**ADDENDUM  
NO. 3**

**September 30, 2025**

**VALE FACILITY ADDITION/RENOVATIONS AND  
MAINTENANCE/IT FACILITY PROJECTS**

**Addendum Three (AD.03)** to the drawings and specifications prepared by Gibraltar Design for **Valparaiso Vale Facility Addition/Renovations and Maintenance/It Facility and Related Work** for Valparaiso Community Schools, Valparaiso, Indiana.

**A-410**

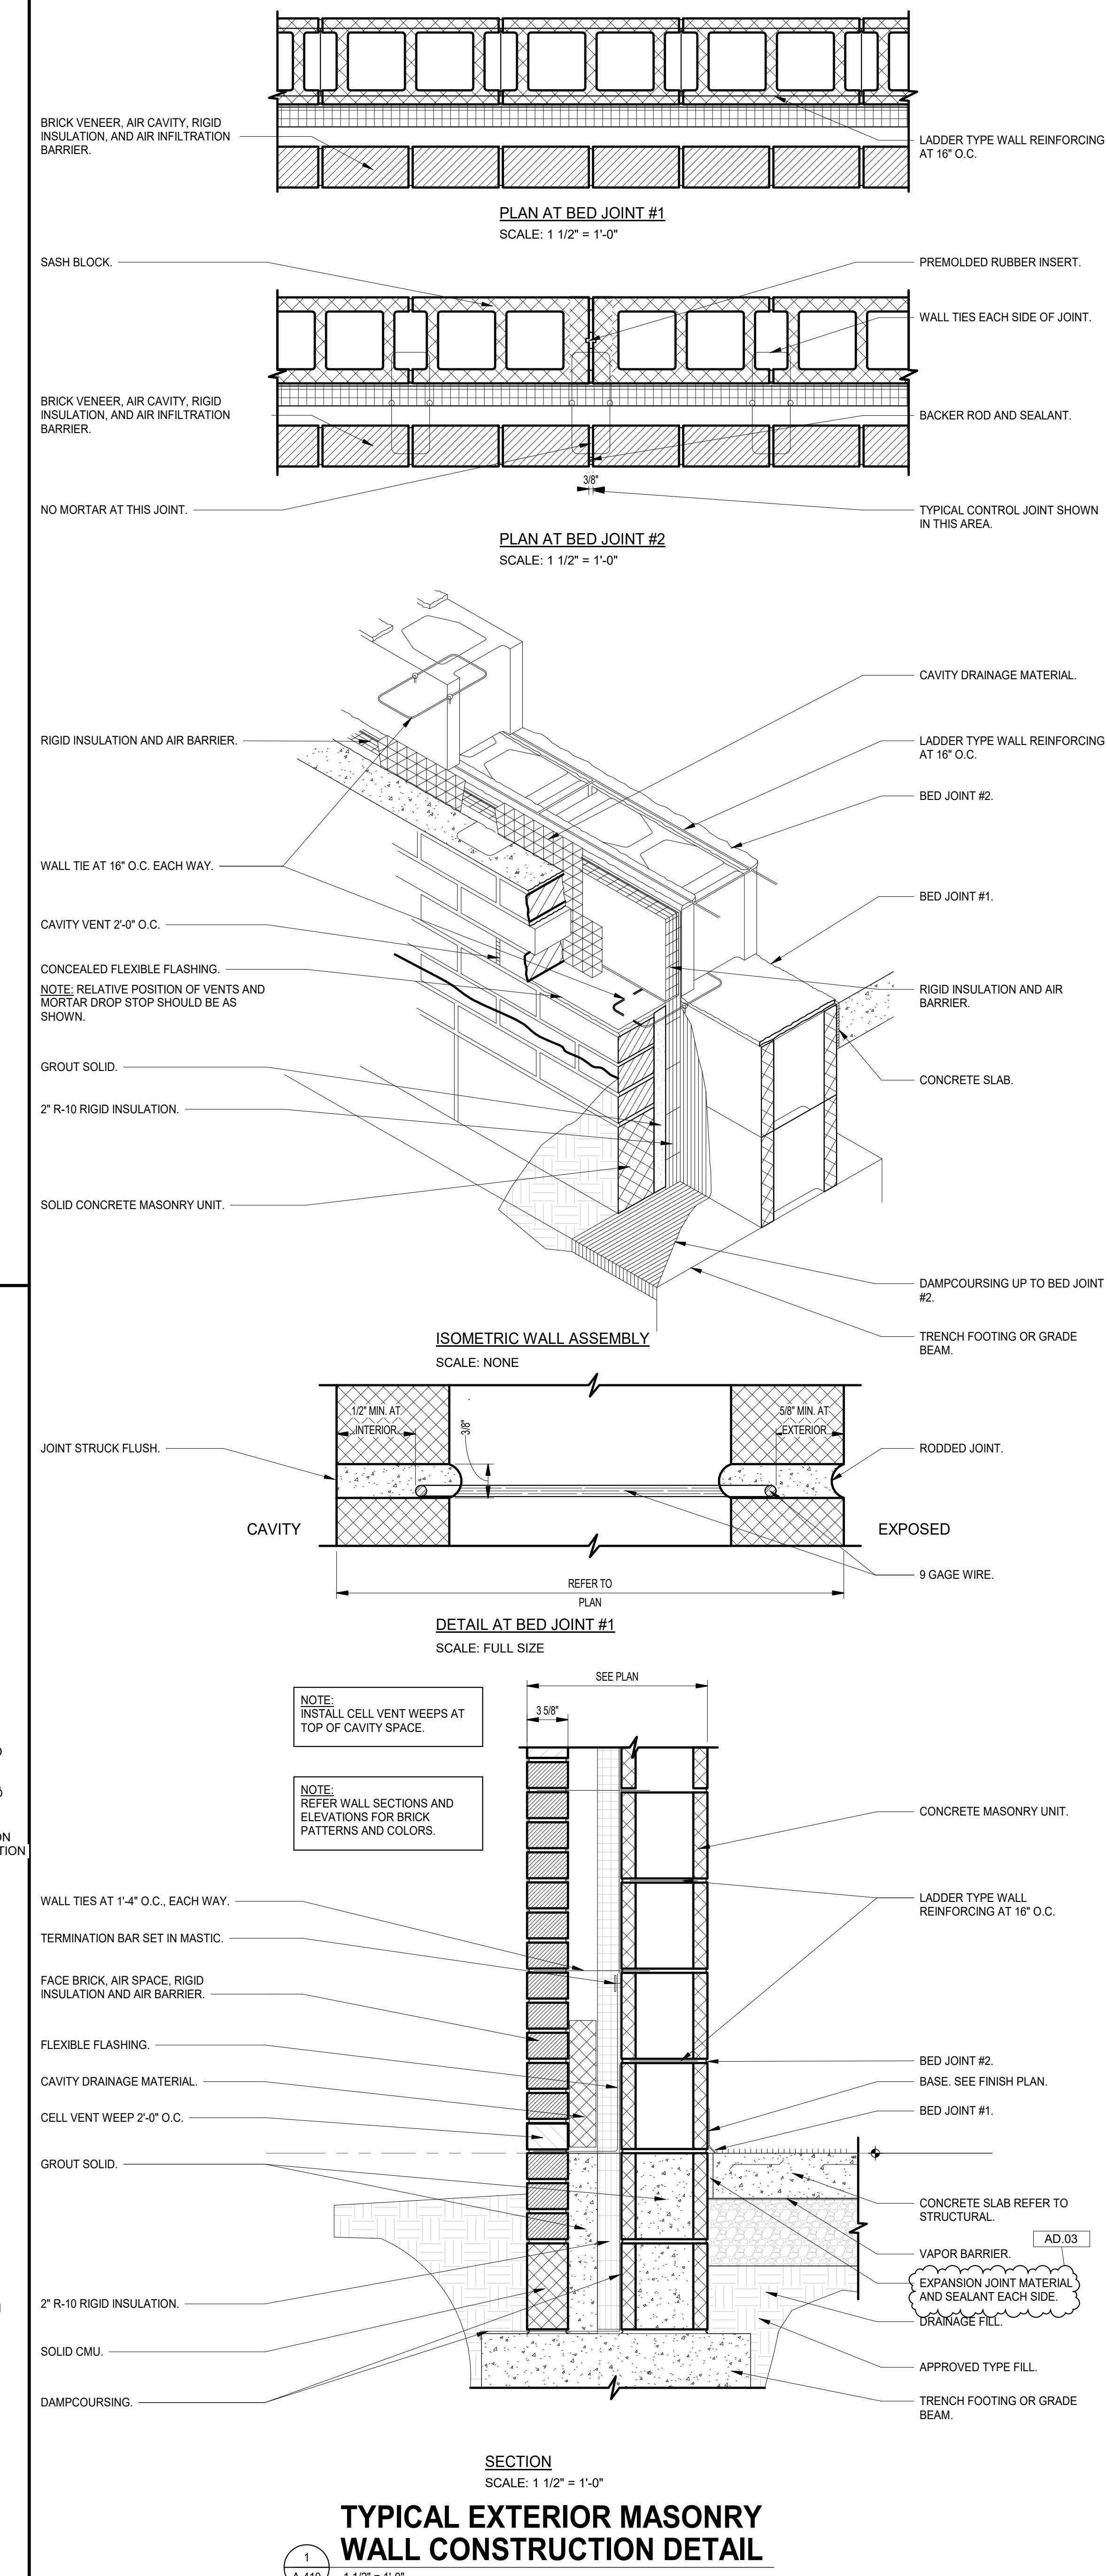
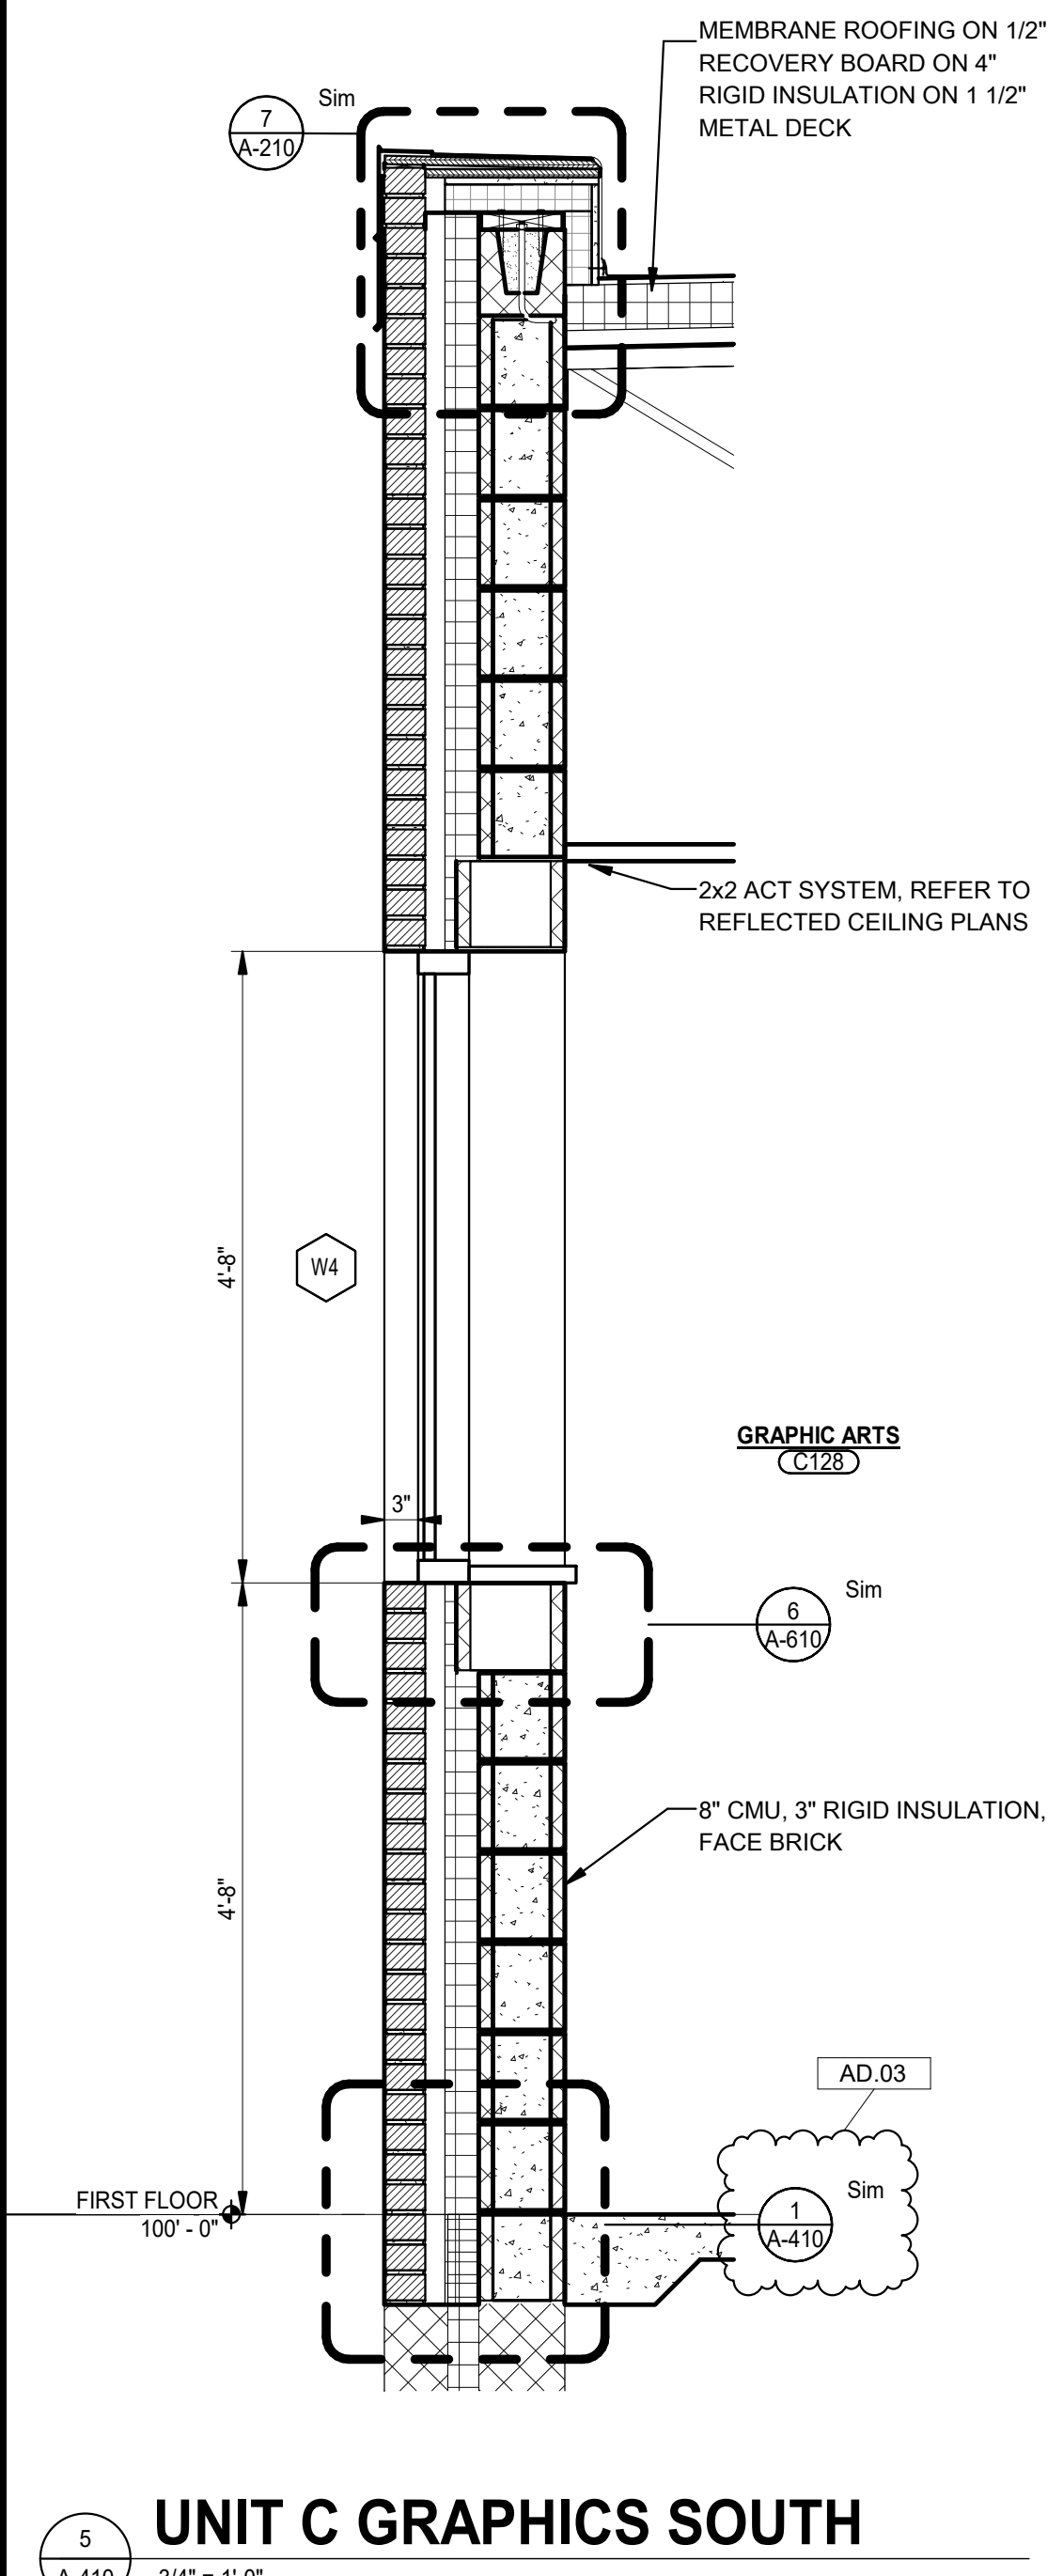
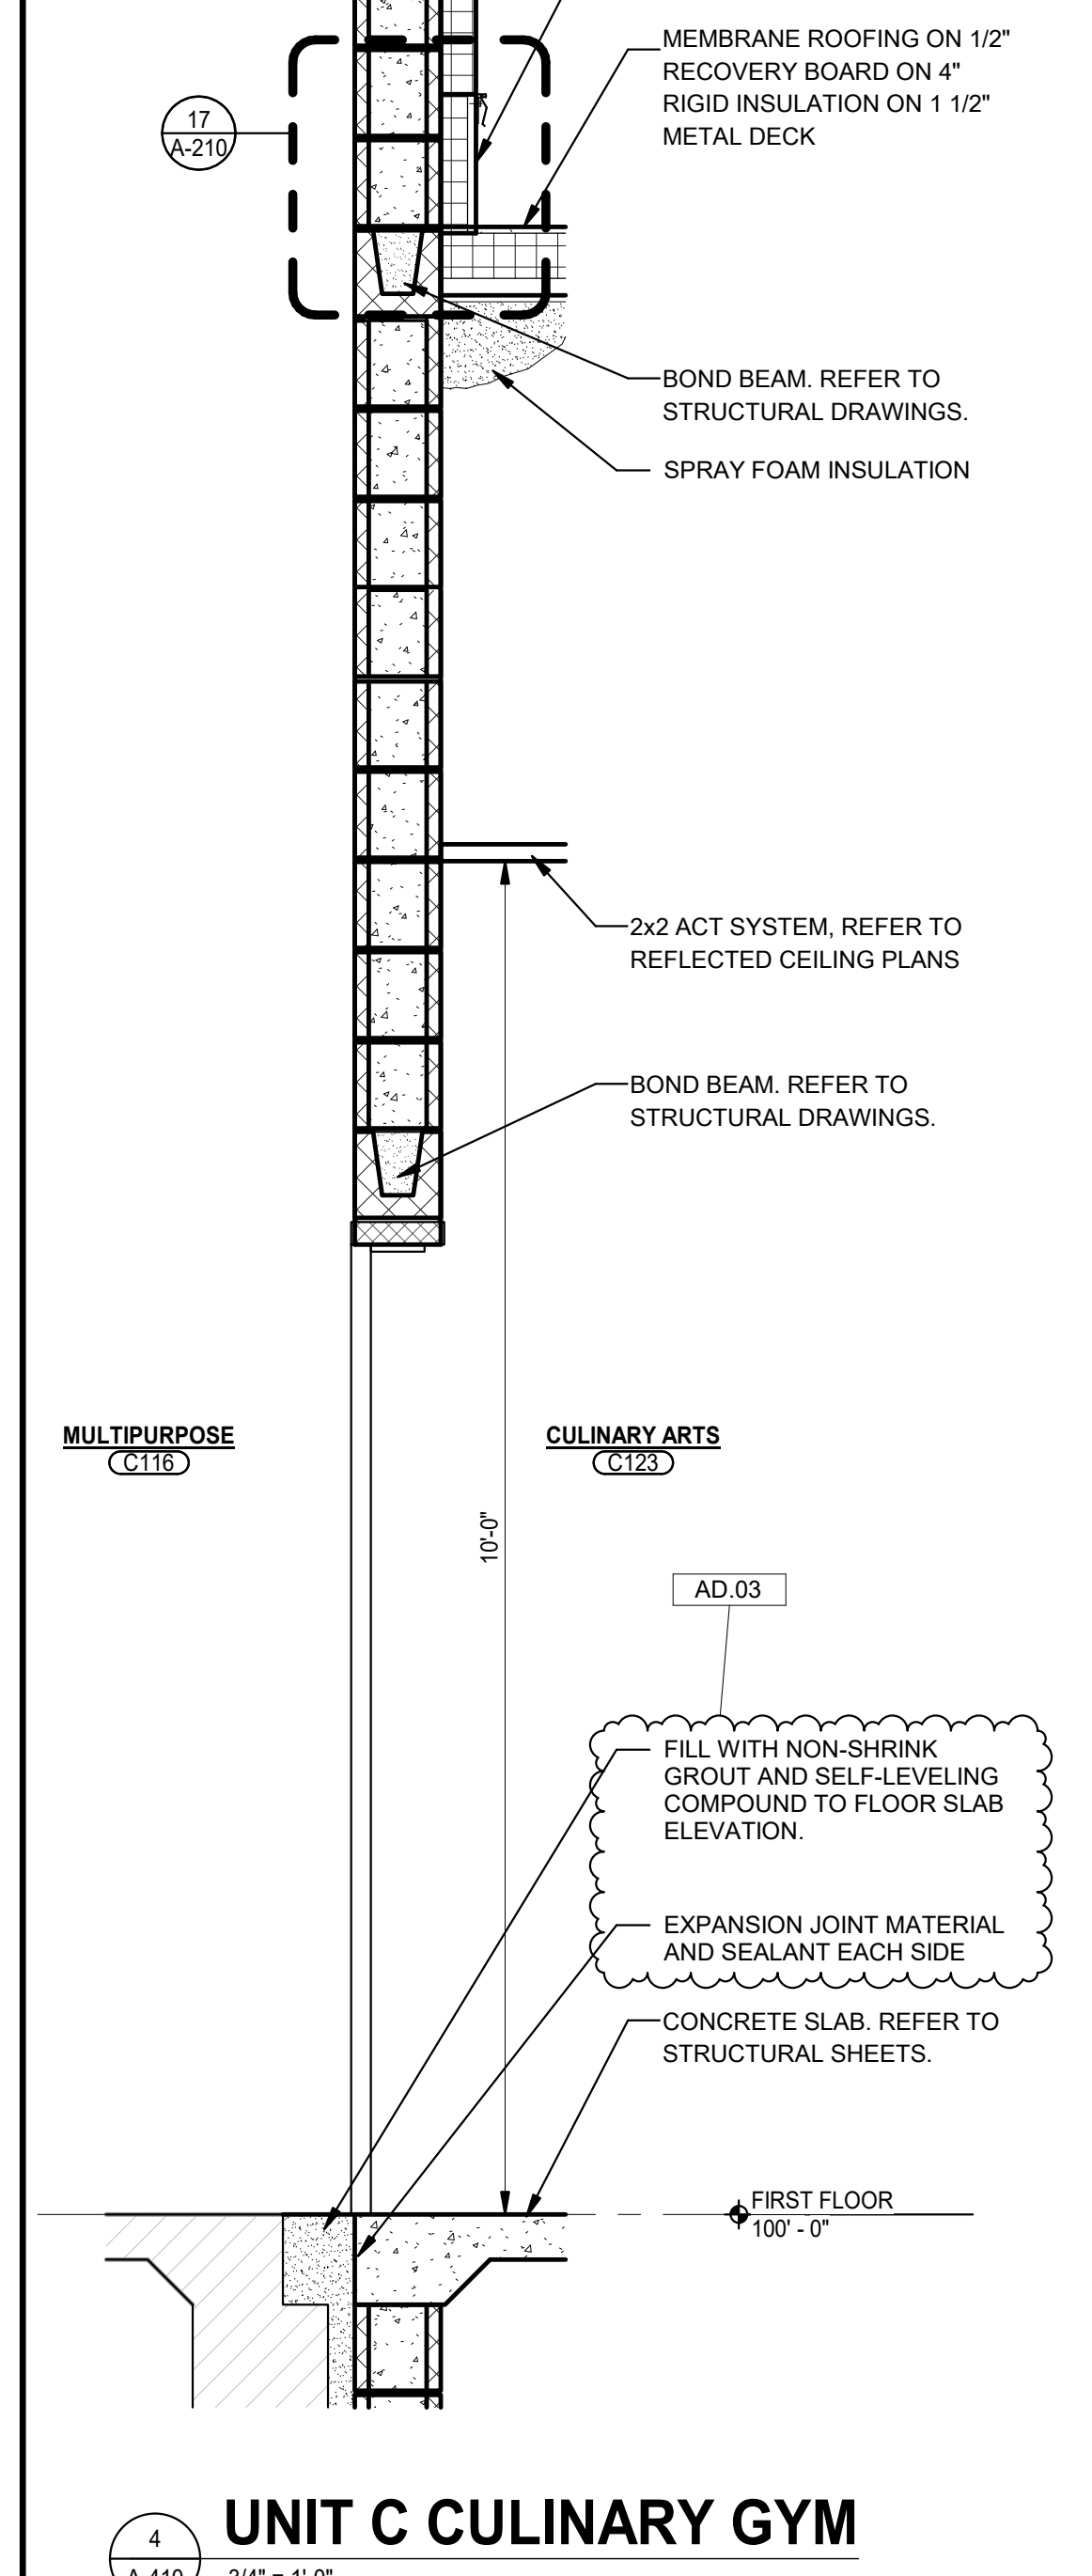
- A. Refer to revised, full-size drawing, included in this Addendum, for revisions.
  - 1. Added / Clarified expansion joints at slab to wall conditions.
  - 2. Clouded bottom of new exterior walls to refer to detail 1/A-410.
